1 Q. **Reference: Long-Term Supply for Southern Labrador – Revision 1 - Schedule 2 - Long-Term**  
 2 **Supply for Southern Labrador - Evidence Supporting the Revised Application**

**Chart 1: Incremental Revenue Requirements for Interconnection vs Isolated**

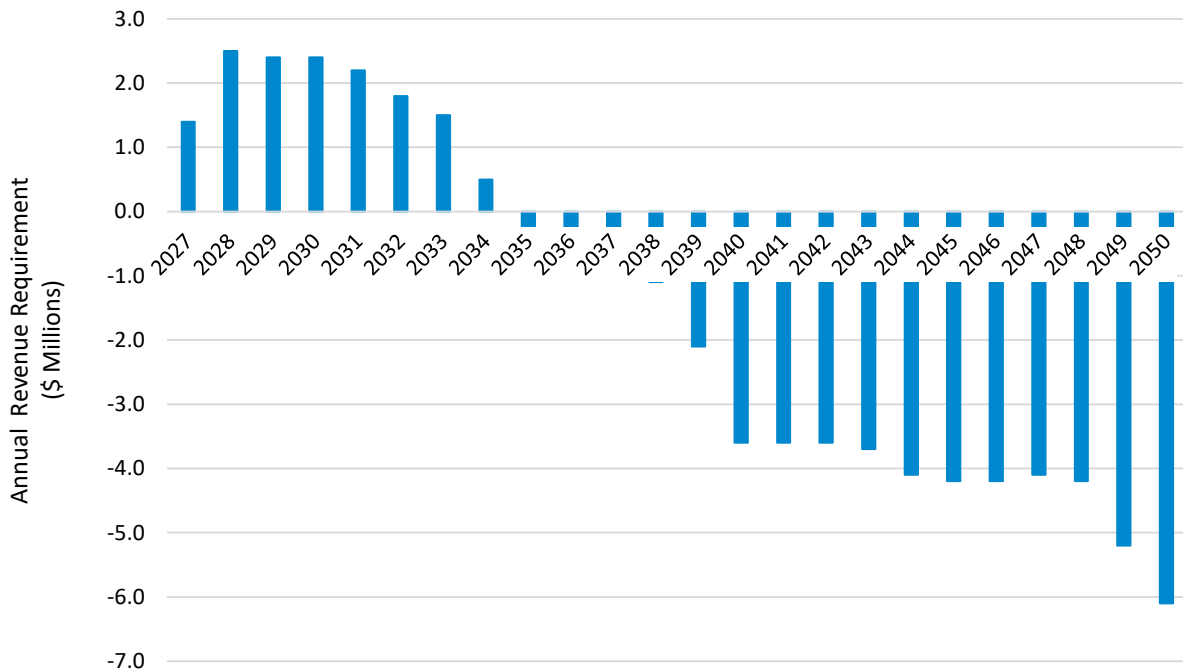
3 Please provide a chart similar to Chart 2 on page 15, and an accompanying table, showing the  
 4 incremental revenue requirements for every year up to 2050.

7 A. Chart 1 and Table 1 include the incremental revenue requirements for every year up to 2050.
